Subject: CASE 13-T-0585 -Application of Cricket Valley Energy Center, LLC for a Certificate of Environmental Compatibility and Public Need Pursuant to Article VII of the Public Service Law For Approval of a New 345 kV Transmission Line From the Pleasant Valley Substation to the Cricket Valley Energy Center, LLC and the Re-Conductoring of an Existing 345 kV Line in the Town of Dover, Dutchess County.

Responses to the Department of Public Service Staff April 18, 2014
Request for Additional Information

Figure S-1

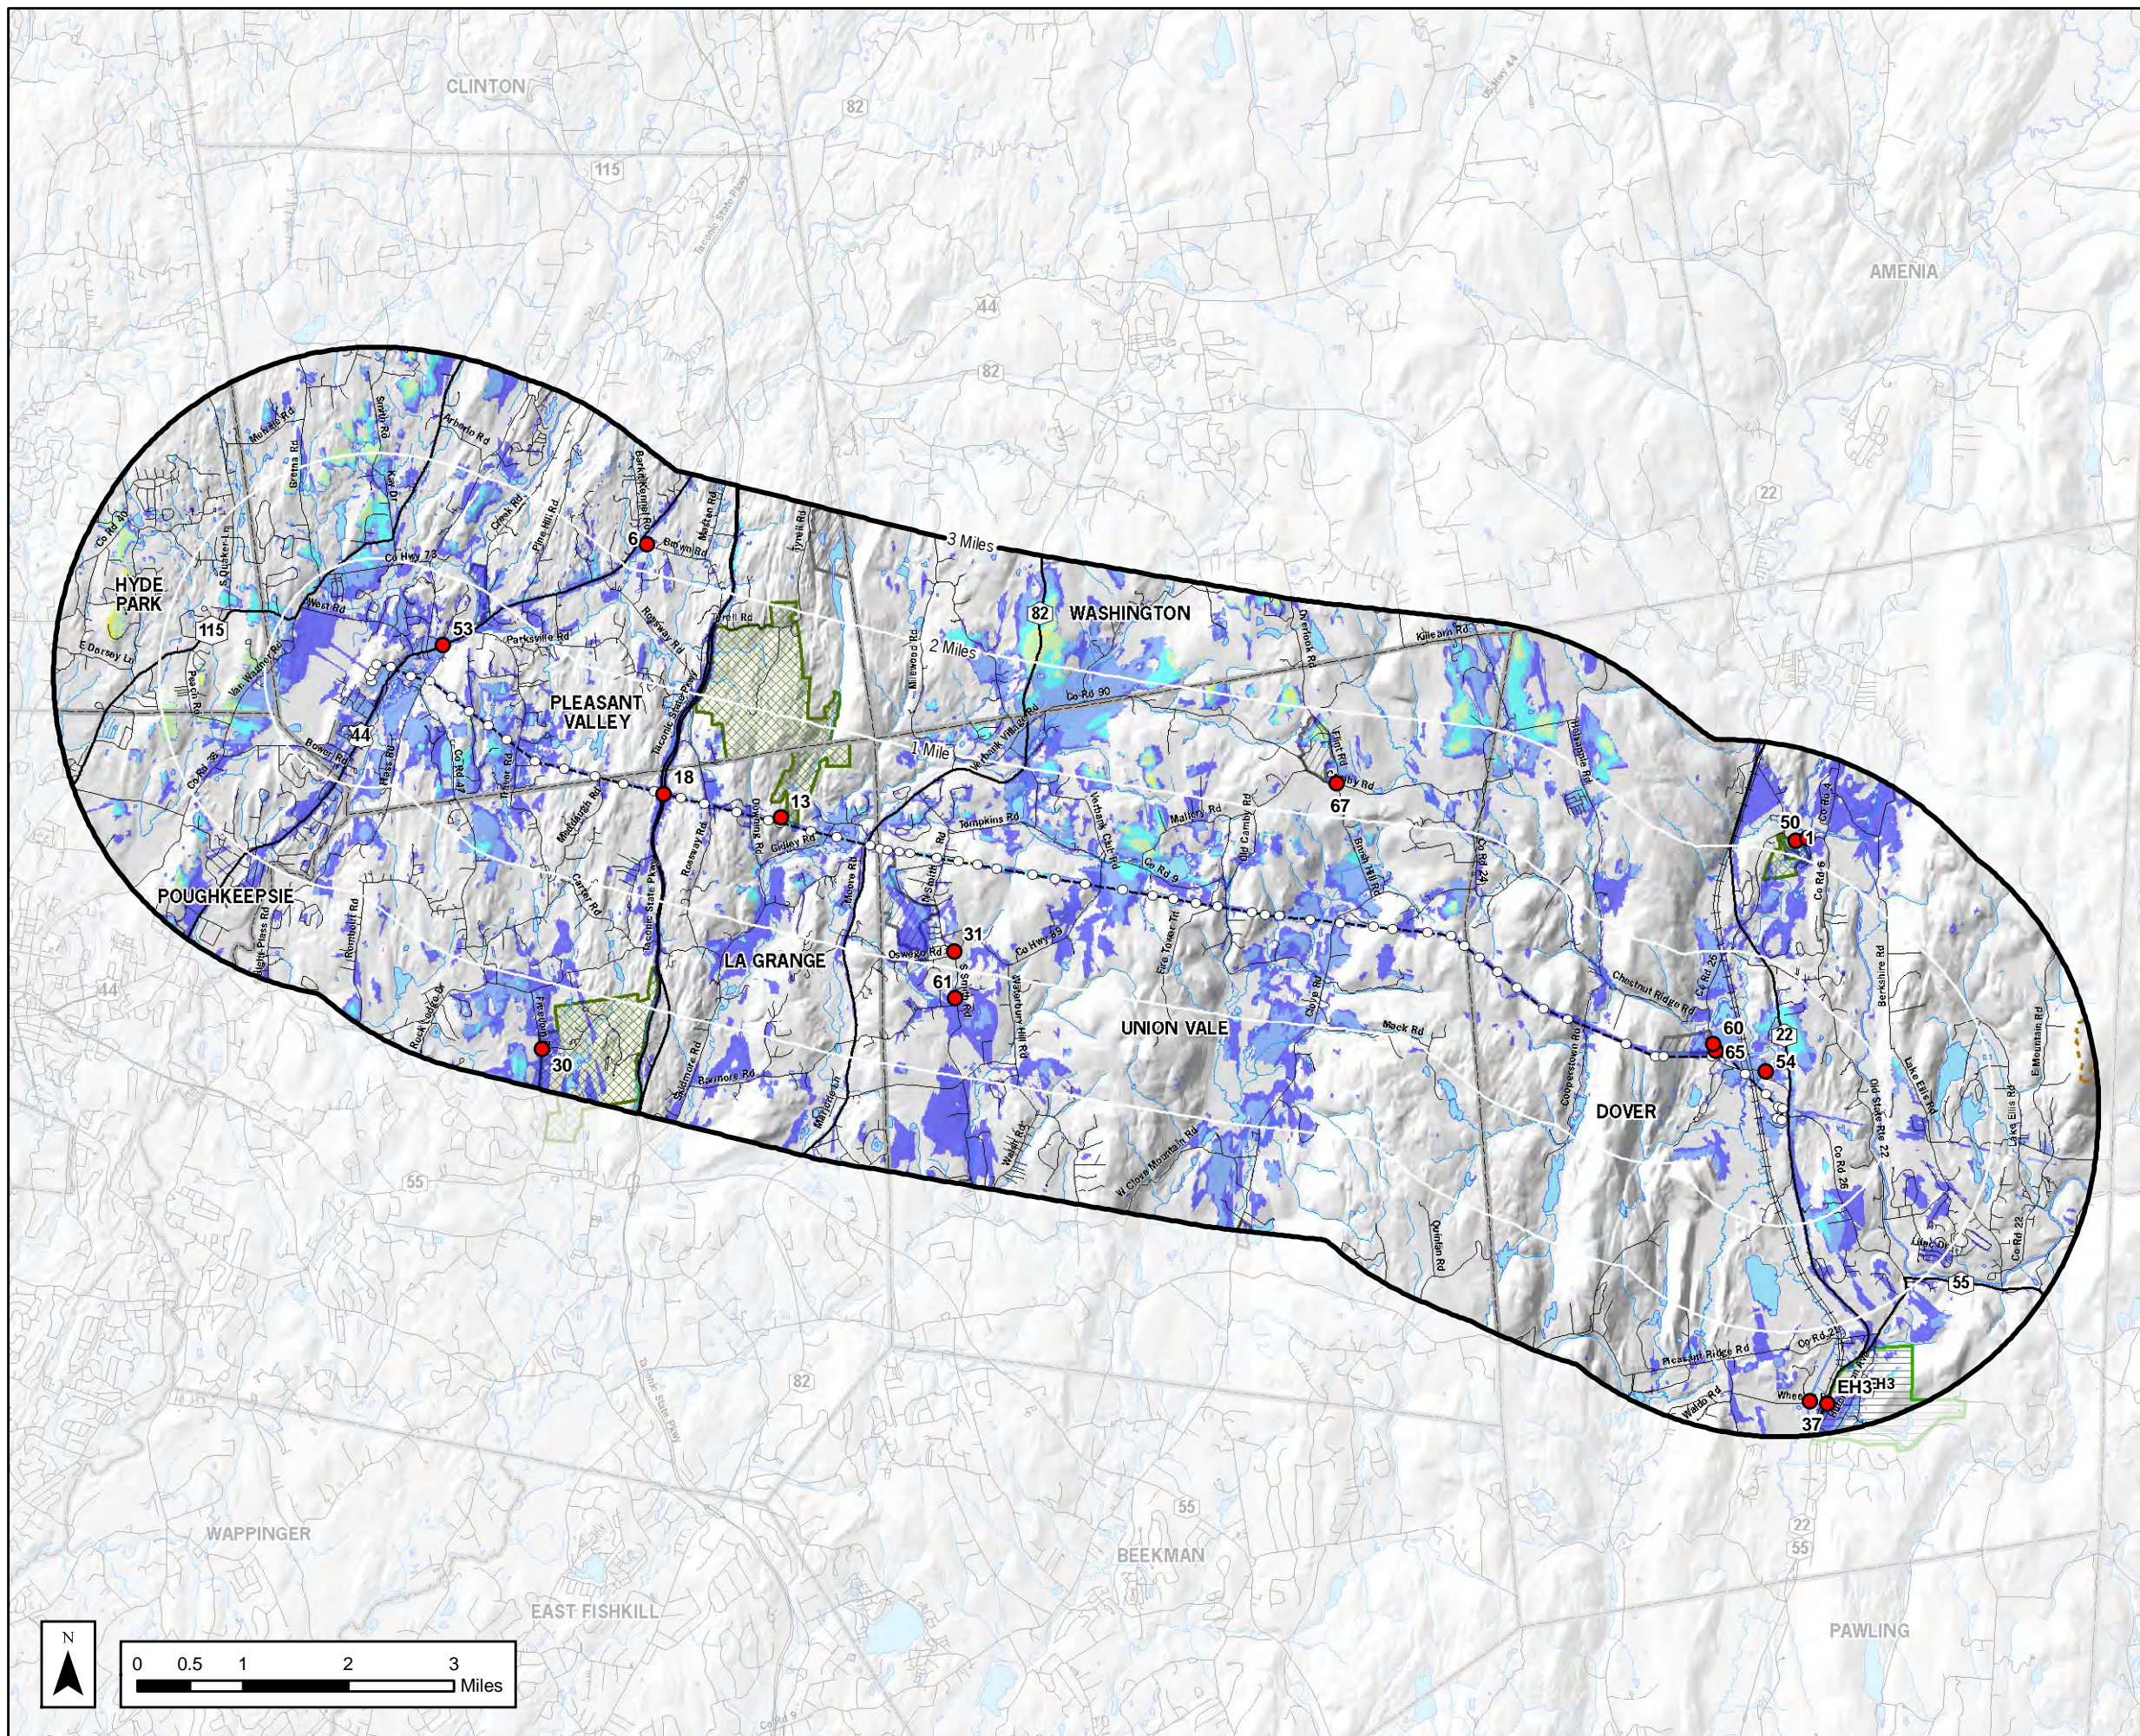
Thirteen visual resources of statewide significance and ten national register eligible historic resources were identified in the VRA. The text discussion in the VRA and Table 5 estimate the number of new utility towers that may be seen from the visual resources of statewide significance. Based on Figures A1, A2, and Table 5 the number of towers that may be visible from a scenic resource of statewide significance is between 0-18. At most locations, multiple towers maybe visible however the actual number will depend on the screening provided by vegetation as stated on page 37. To show that the new power line has been located to minimize visual impacts, additional existing condition photographs from selected scenic resources of statewide significance are necessary. These photographs should demonstrate the visibility of the existing power line, which is an accurate baseline for the future conditions. The VRA has included photographic simulation that emphasizes the near view images and there are five existing condition photographs in the report, which is not adequate to build a general understanding of the visual setting. Including additional photographs from statewide visual resources will fill out the VRA. The applicant should submit additional photographs or identify locations where photographs can be taken to complete the VRA.

Response to #3: Attachment B to this letter includes a photographic layout, key map to photo locations, and a description of means and methods prepared by Saratoga Associates, Inc. to address the Commission's requests.
